**SUBJECT:** Re-submittal of Safety Evaluation by the Office of Nuclear Reactor Regulation of Electric Power Research Institute (EPRI) Topical Report TR-1002865, "Topical Report on Reactivity Initiated Accidents: Bases for RIA Fuel Rod Failures and Core Coolability Criteria"

**PROJECT: 669**

**SUBJECT:** Safety Evaluation by the Office of Nuclear Reactor Regulation of Electric Power Research Institute (EPRI) Topical Report TR-1002865, "Topical Report on Reactivity Initiated Accidents: Bases for RIA Fuel Rod Failures and Core Coolability Criteria"

**Response to Requests for Additional Information (RAI's)  
NRR Safety Evaluation Report – Project No. 689**

Figure C-1.1 Comparison of fuel centerline temperature predictions by FALCON BETA RIA, using MATPRO-11/ESCORE, FRAPTRAN and NFIR thermal conductivity models with thermocouple measurements for the Halden irradiation test IFA-515.10 Rod A1.

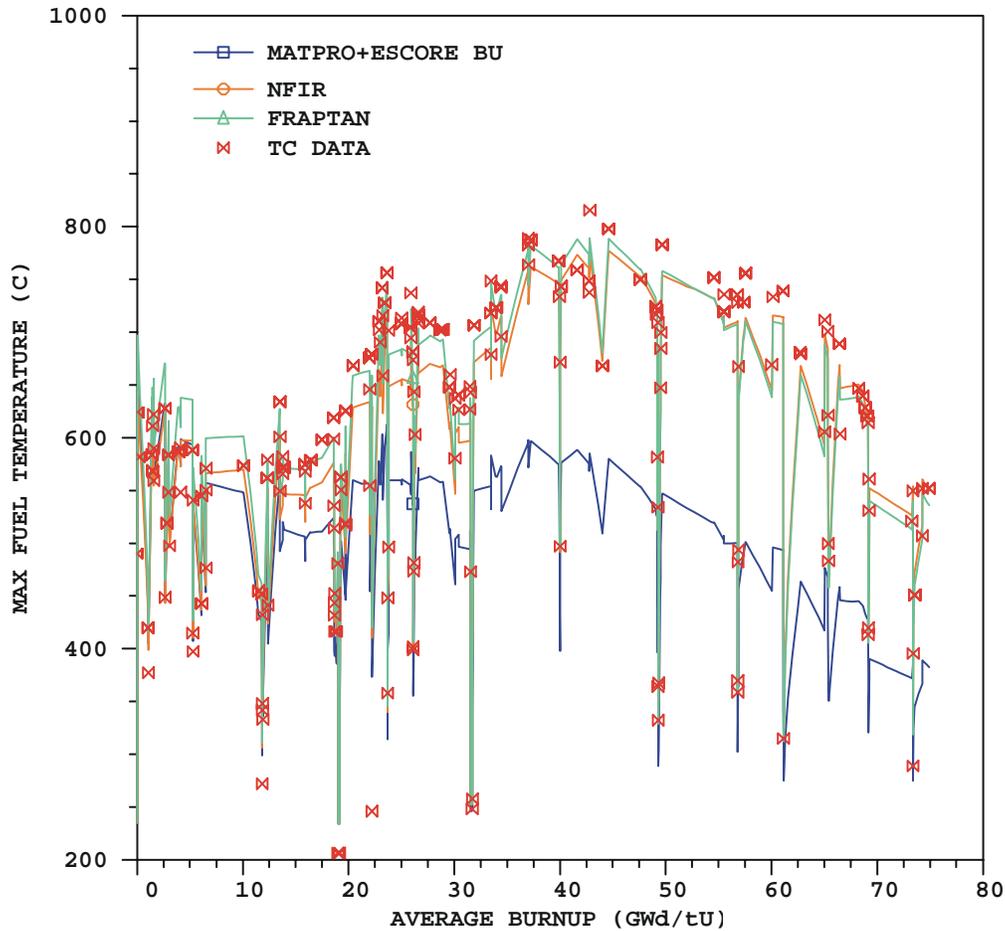
The basis for the statement on the underestimation of the fuel temperature at high burnup in FALCON was not provided; so several aspects and considerations for the coolability calculation are described below. The response comprises two parts: 1) validation of the best-estimate fuel temperature calculation in FALCON under RIA conditions against applicable data and 2) sensitivity of the fuel temperature calculation to the UO<sub>2</sub> thermal conductivity model.

Comparison of the FALCON BETA-RIA steady state temperature calculations with thermocouple measurements shows that the baseline  $\text{UO}_2$  thermal conductivity correlation results in a underestimation of the fuel centerline temperatures by ~200°C at pellet average burnup levels exceeding 30 GWd/MTU. A comparison to thermocouple measurements for the Halden irradiation test IFA-515.10 Rod A1 is shown in Figure C-1.1. Also shown for comparison is the FALCON calculated fuel temperatures using the FRAPTRAN [C-1.4] and NFIR [C-1.5, 6]  $\text{UO}_2$  thermal conductivity correlations. The results for these two correlations agree well with the thermocouple data and are almost indistinguishable from each other.

For steady state conditions, heat transfer across the pellet is primarily a function of the pellet thermal conductivity. However, this is not the case for RIA conditions. The rapid nature of the energy deposition results in an almost adiabatic condition where the maximum fuel temperature depends mostly on the  $\text{UO}_2$  specific heat capacity, the radial power distribution, and the deposited energy. Therefore, it is not possible to evaluate the capability of a code to calculate fuel temperatures during rapid RIA conditions using steady state thermocouple measurements.

Figure C-3.1 Comparison of the Coolability Limit Proposed in the EPRI Topical Report and the Japanese Coolability Limit [C-3.2]. Selected high fuel enthalpy test rods shown for comparison.

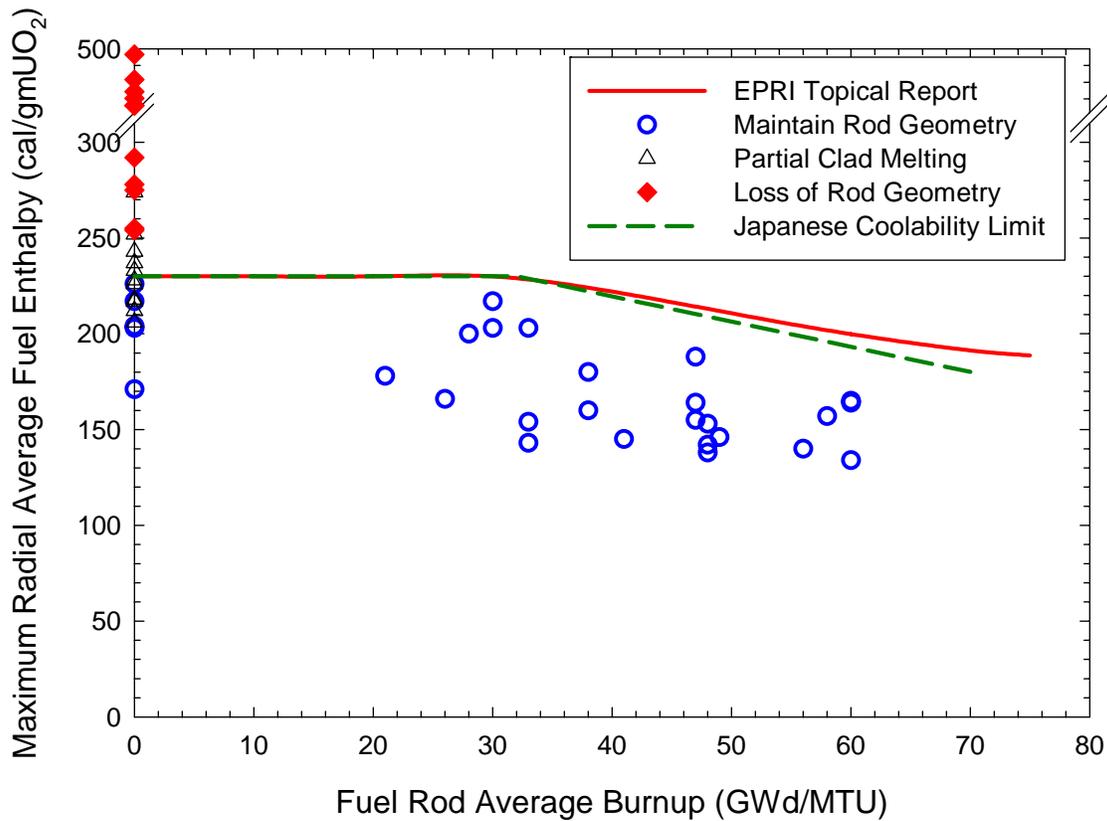
C-3. Although we believe there may be a justifiable coolability limit at an enthalpy above the Research Information Letter (RIL)-0401 cladding failure threshold, we cannot accept the proposed limit because of the lack of experimental data. Assertions are made about limited amounts of fuel dispersal, small magnitude of pressure pulses, and inefficient energy conversion of non-molten particles. However, these assertions are based mostly on tests in the Nuclear Safety Research Reactor (NSRR) with medium-to-high-burnup specimens under conditions that are far from typical for a nuclear power plant. No analysis is presented that would allow one to interpret these data or to compare predicted light-water reactor pressure pulses with vessel limits. We do not believe it is adequate to assume that molten fuel is needed to produce an energetic fuel-coolant interaction and then use a burnup-dependent melt enthalpy as the limit.

**Response to RAI C-3:**
